ZONING ADMINISTRATOR MEETING AGENDA

PUBLIC HEARING**2. SC24-0006 – Narinder Paul – 1501 Oakley Drive**

SUBMITTAL OF PLANNING APPROVAL FOR
PAUL RESIDENCE
1501 OAKLEY DRIVE
LOS ALTOS, CA 94024
APN:318-10-025

A-2.2

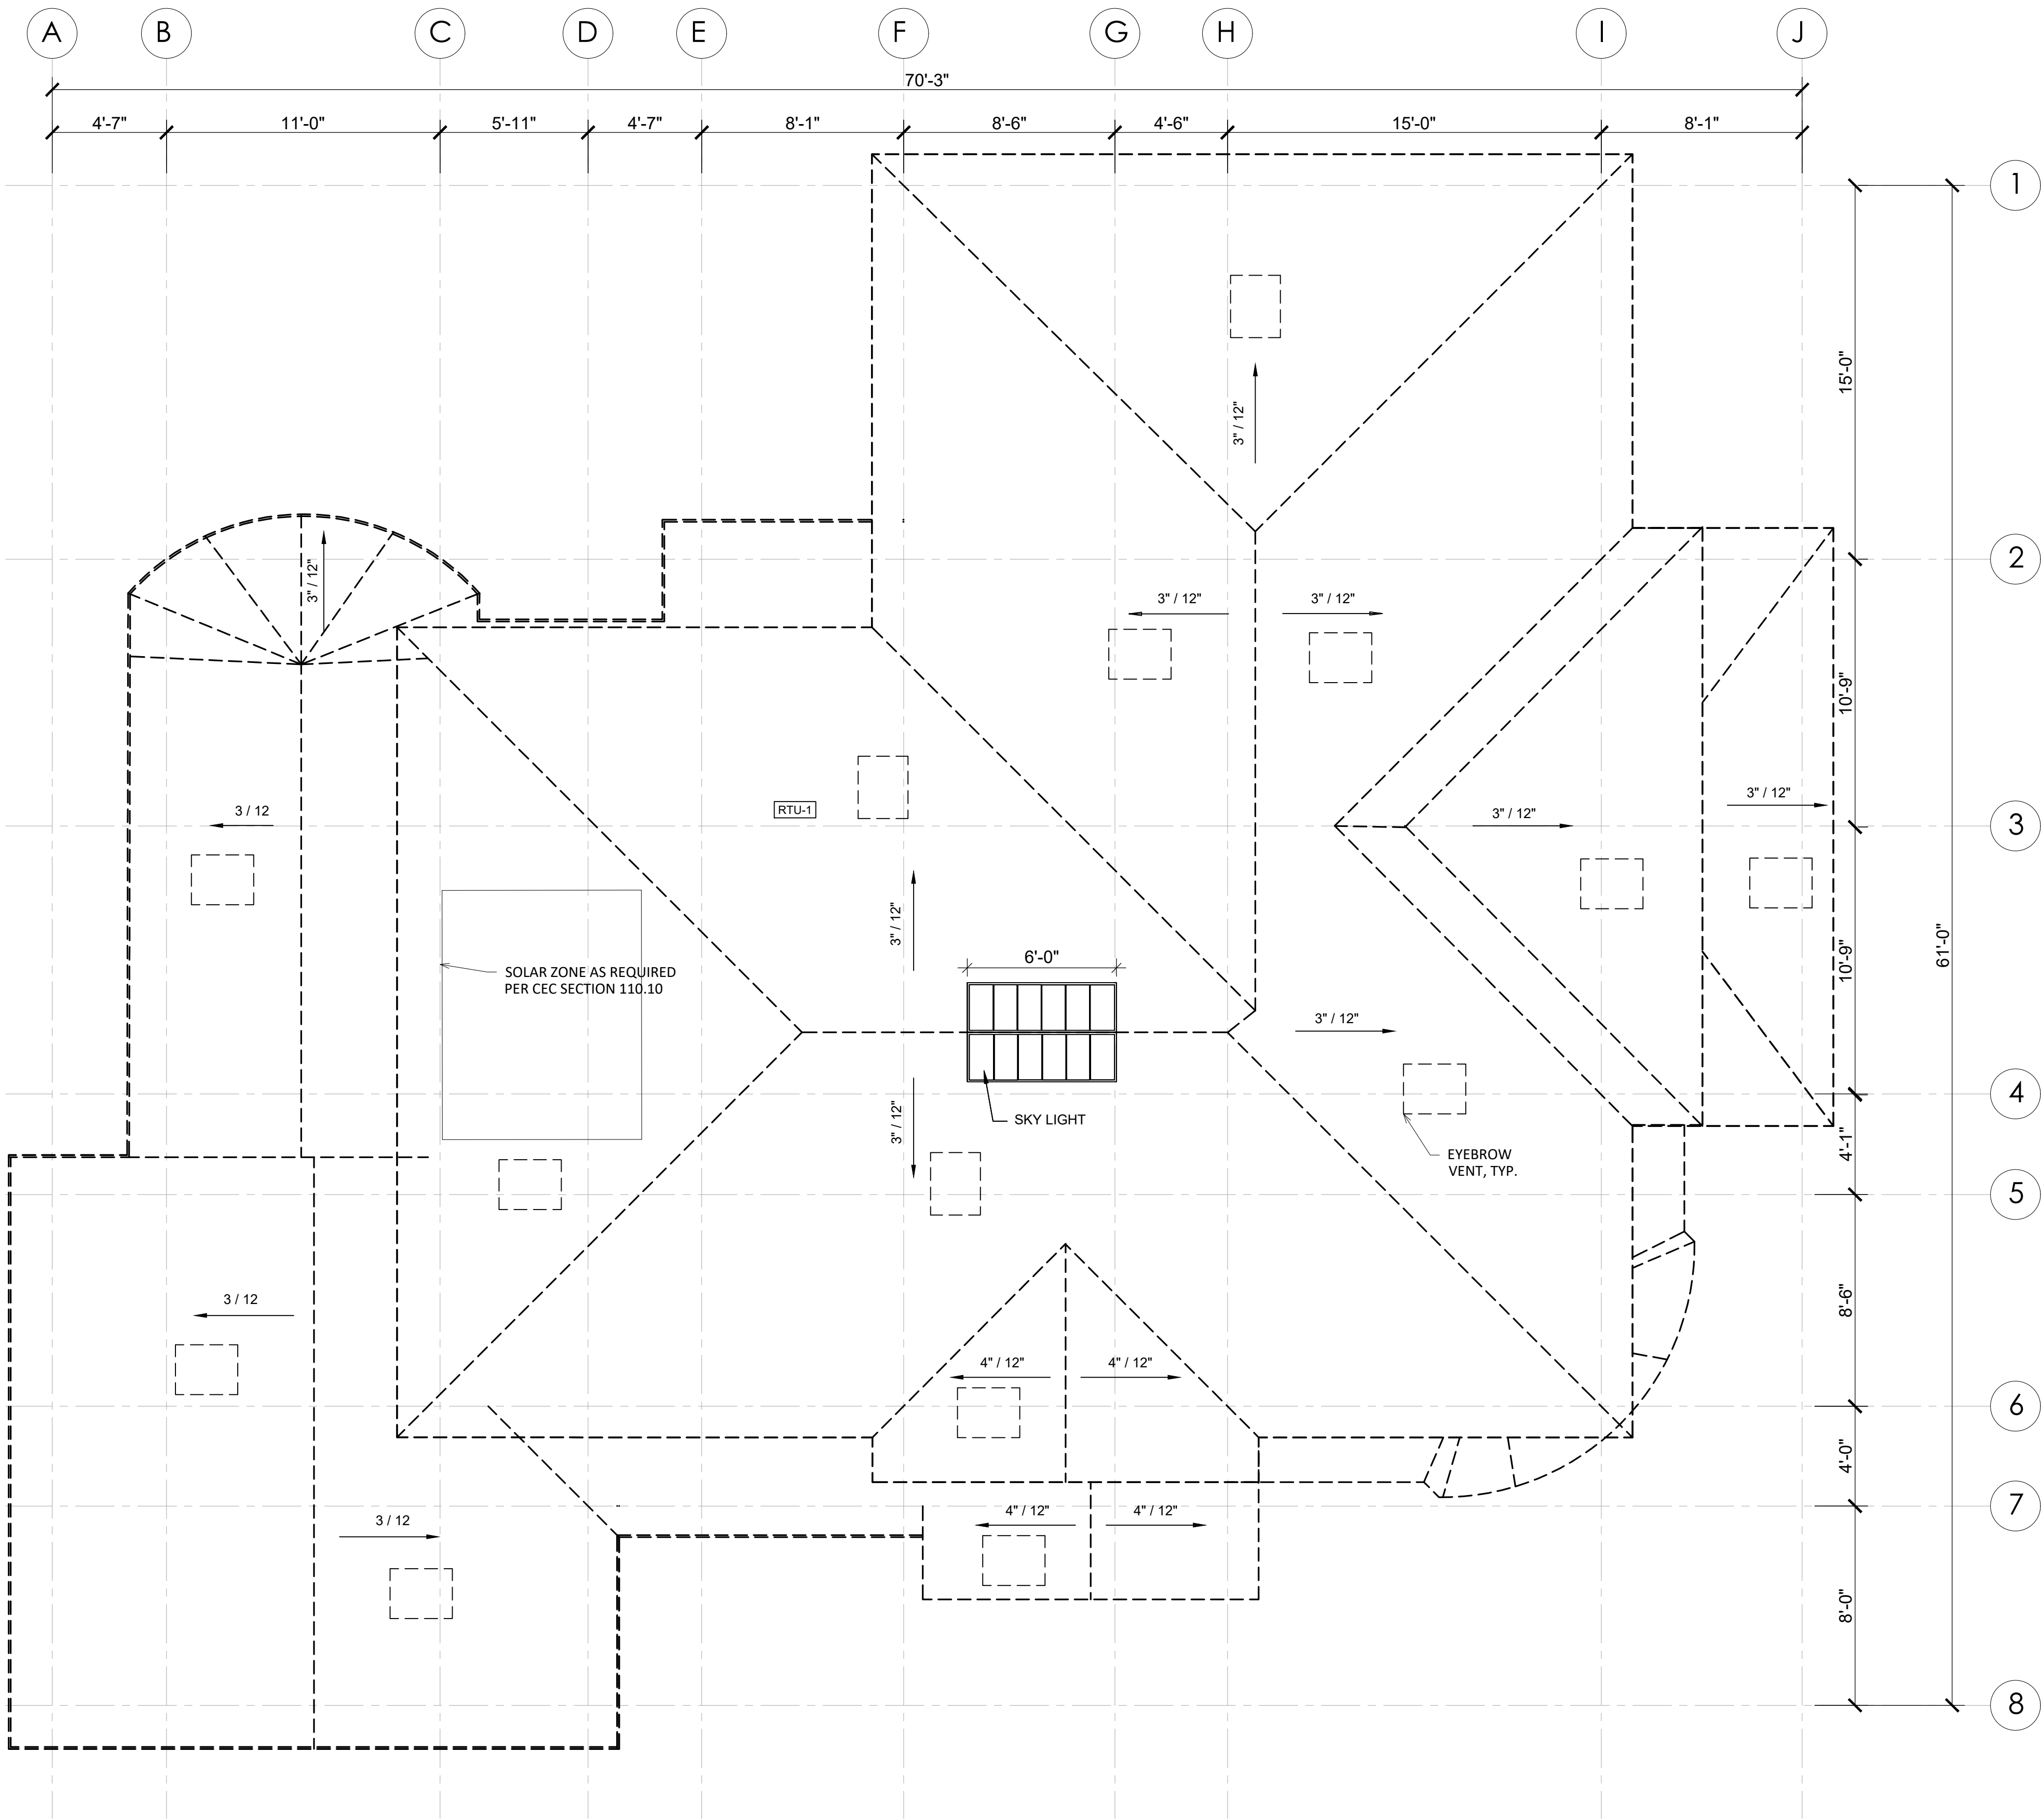
The street facing balcony is drawn at least three different ways in these plans. Floor plan A-2.2 indicates that the first-floor projects 4'-0" from the second floor. As such, a first-floor roof will extend from the second-floor wall. In the front elevation, page A-3.0, the roofs on opposite sides of the entry are indicated to be the same vertical height. This is geometrically impossible. The roof closest to the garage will extend vertically as it must grow significantly taller than the fake band on the right to meet the second-floor wall behind it. Even though roofs on left and right of the entry are dramatically different in height, they are incorrectly illustrated as if to match. The balanced roofs illustrated in the elevation (sheet A-3.0) are an errant and impossible misrepresentation of the design (see fig. A).

A-3.1

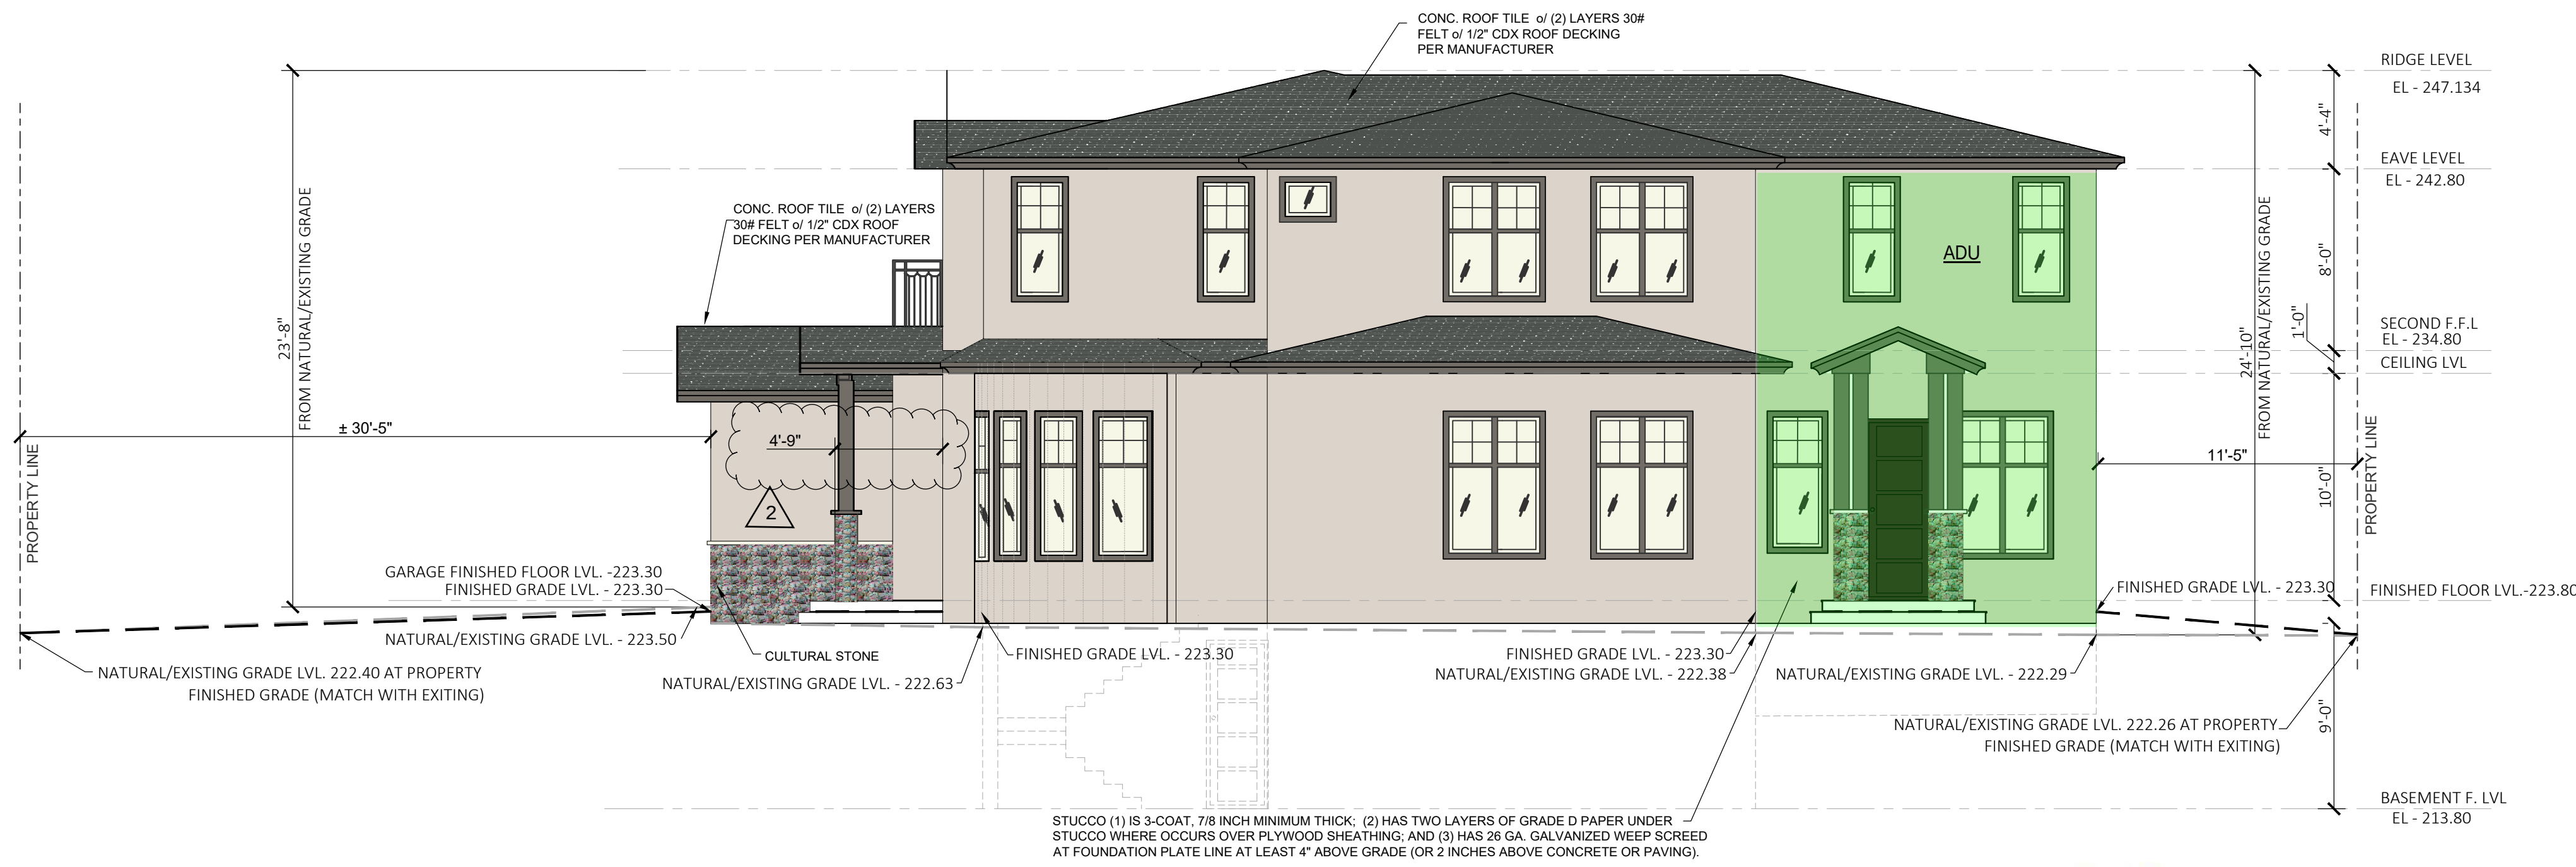
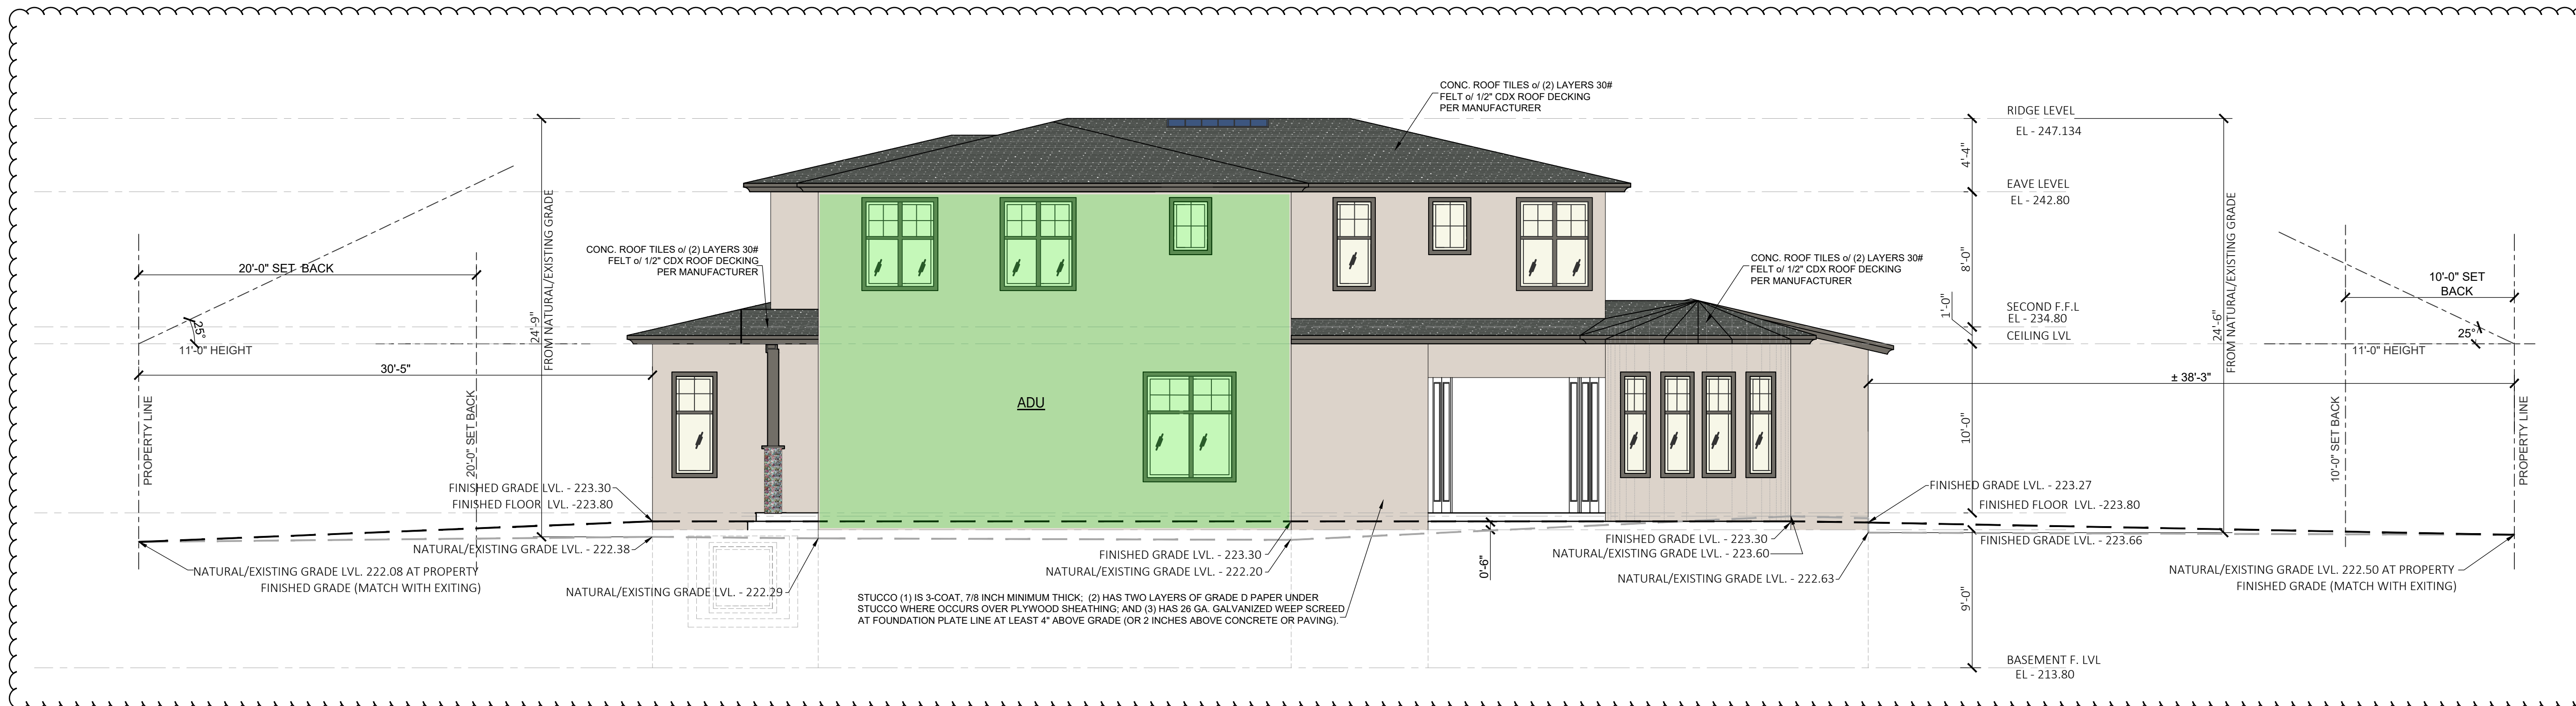
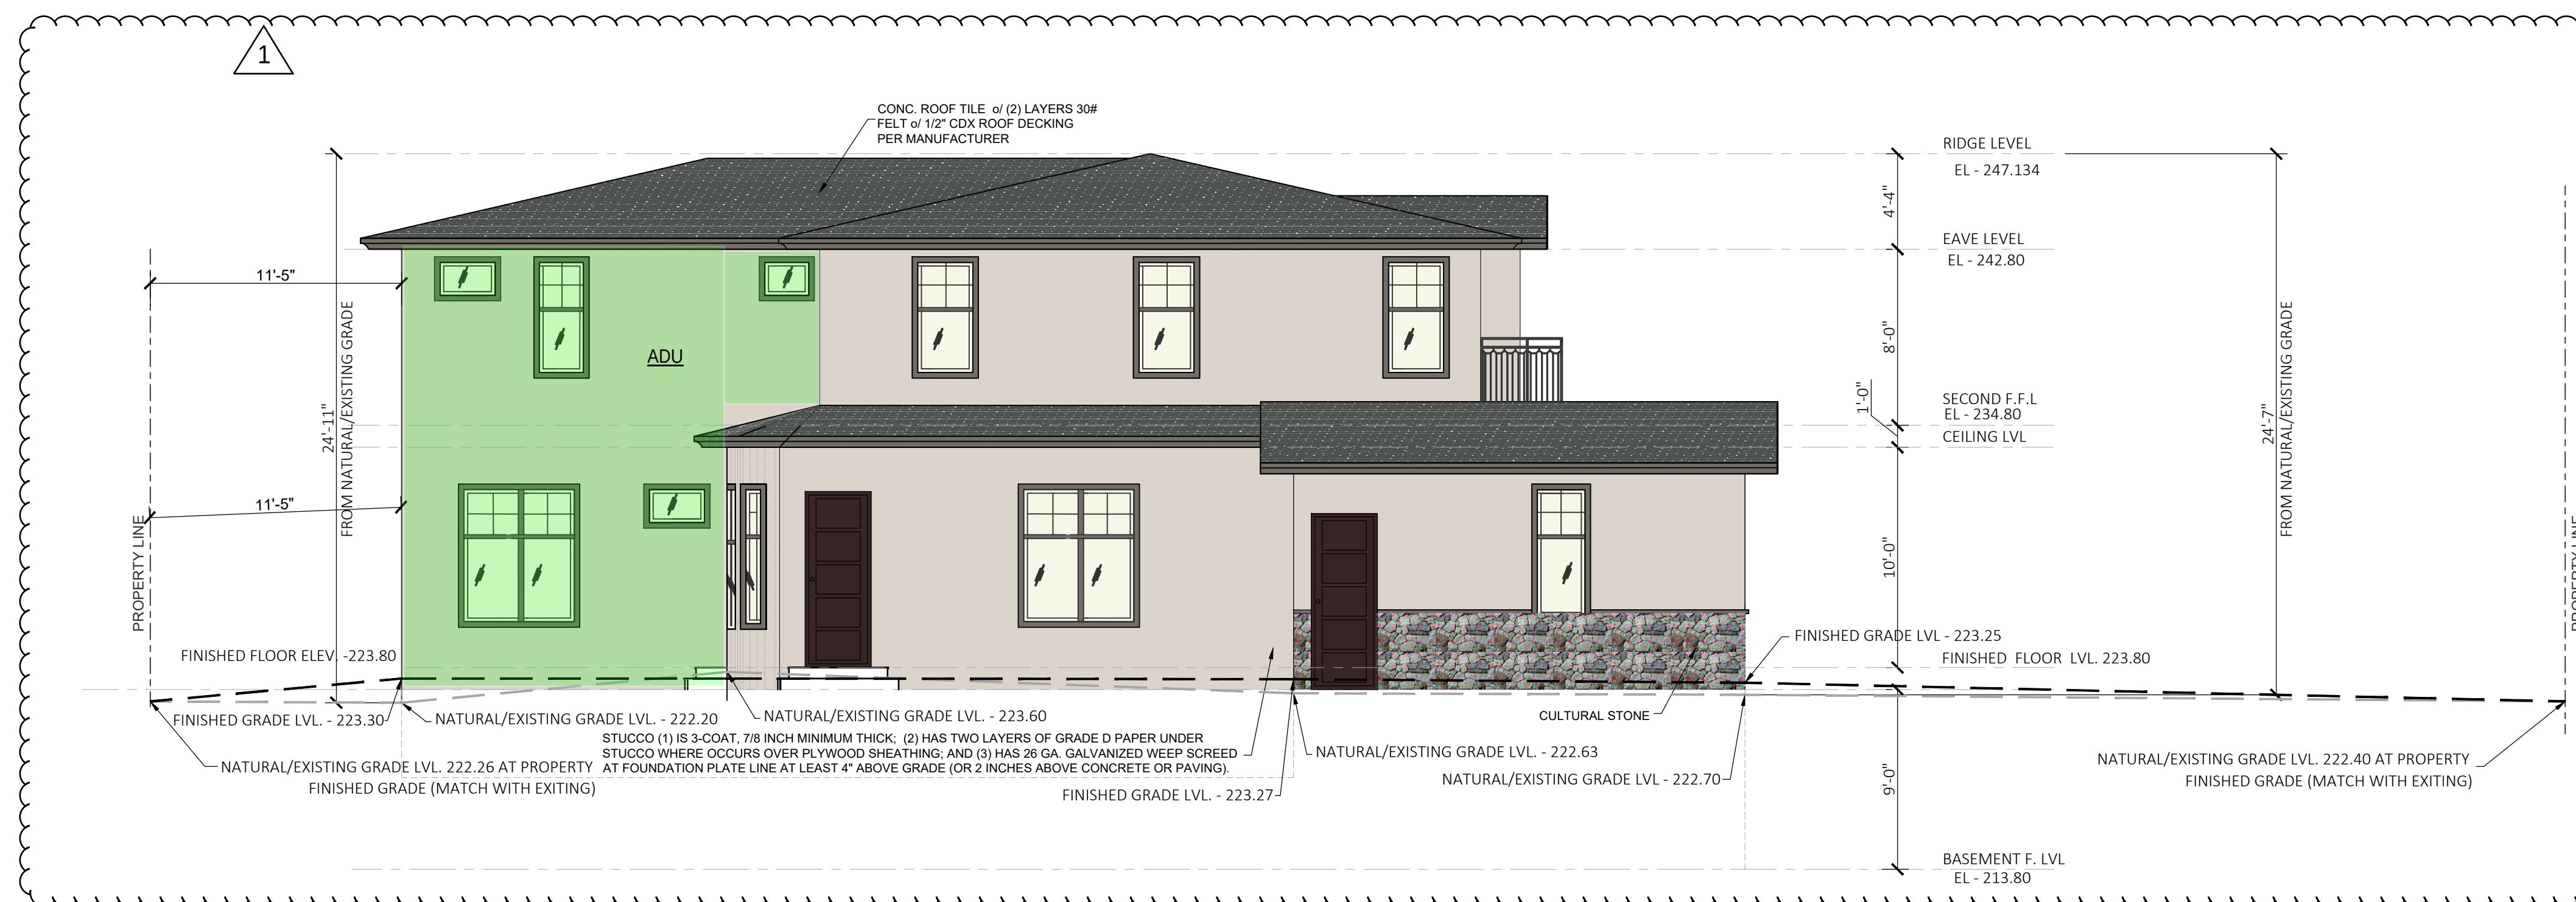
- c. On the Elevation Drawings:
 - i. Correct the labels for the side elevations to indicate Right Elevation for the ADU entry/street side and Left Elevation for the garage side.

- ii. Revise the wainscoting depicted on the elevations to match the Cover Sheet rendering.
